Window W4 - C/G 1:5

OSBORNESCHARTEREDARCHITECTS
The Balconies • Hanley Swan • Malvern • Worcestershire • WR8 0DN
T: 01684 311303 E: architecture@osbornesarchitects.com F: 01684311255 W: osbornesarchitects.com
CLIENT AMBASSADOR THEATRE GROUP
PROJECT MANCHESTER OPERA HOUSE
TITLE WINDOW REPAIR - W4-C/G
SCALE 1:5; NTS @ A1
DATE MAR 2020
DRAWN AML
DRAWING NUMBER 19-143- WR4

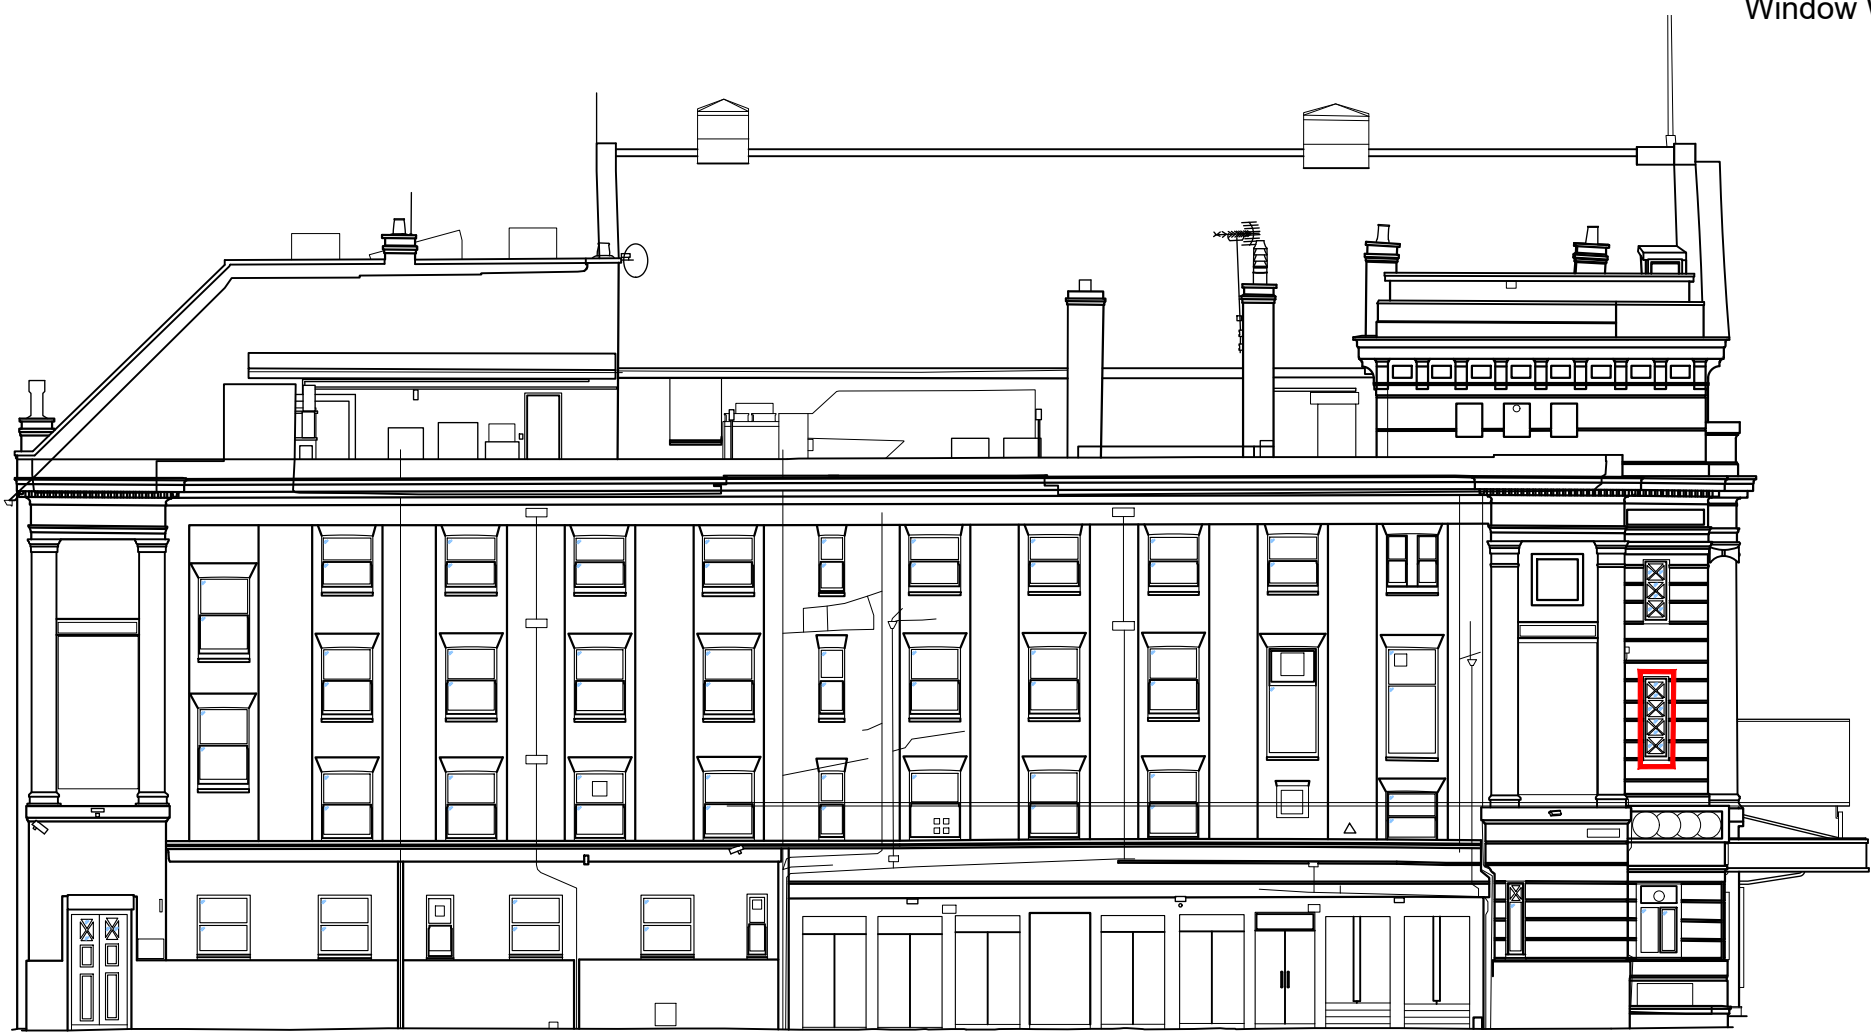
Carefully remove beads to allow for existing broken glass to be removed and new glass to be replaced. New glass to match existing. Ensure bead is labeled for replacement in original location.
Also see general notes on glass replacement.

Replace bead to match existing bead detail in all areas indicated on window, where missing or damaged.
To avoid damage to glass remove existing putty using non-caustic solvent paint stripper as manufacturers instructions and cover with polyethylene film to prevent drying out. Once putty is softened sufficiently, remove by careful scraping. Further applications may be required depending on thickness of putty.

Due to limited access repairs to frame and beads will need assessing once window has been removed and is fully accessible for further investigation.
